3GPP TSG-T (Terminals) Meeting #12
Stockholm, Sweden, 13 - 15 June 2001

Tdoc TP-010106

Title: Change Requests to 3GPP 11.14 and 31.111 "(U)SIM application Toolkit"

This document contains several change requests to TS 11.14 and 31.111 as agreed by T3.

# 5.2 Structure and coding of TERMINAL PROFILE

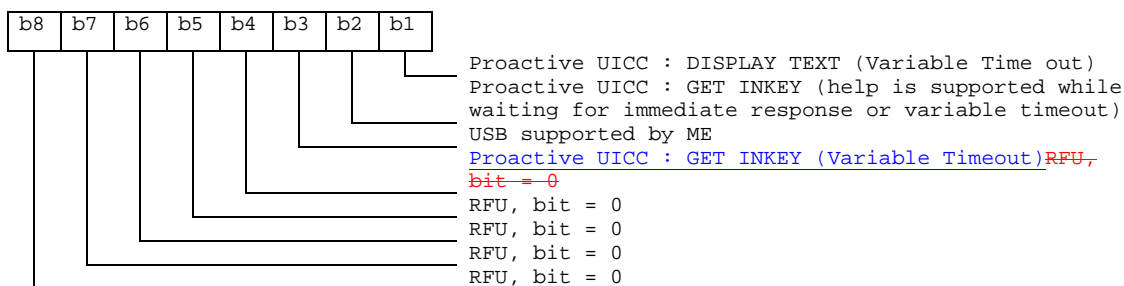
Summary of change: ⌘	IMUI replaced by IMSI
	Deletion of some changes detected by the ME before sending the ENVELOPE (EVENT DOWNLOAD – Channel status) command to the UICC.
	Correction on byte numbering and length value in section 8.47, 8.48, 8.51
	Addition of the Get-Inkey (Variable Timeout) bit to the TERMINAL PROFILE

Proactive UICC : DISPLAY TEXT (Variable Time out)
Proactive UICC : GET INKEY (help is supported while waiting for immediate response or variable timeout)
USB supported by ME
Proactive UICC : GET INKEY (Variable Timeout)RFU, bit = 0
RFU, bit = 0
RFU, bit = 0
RFU, bit = 0
RFU, bit = 0
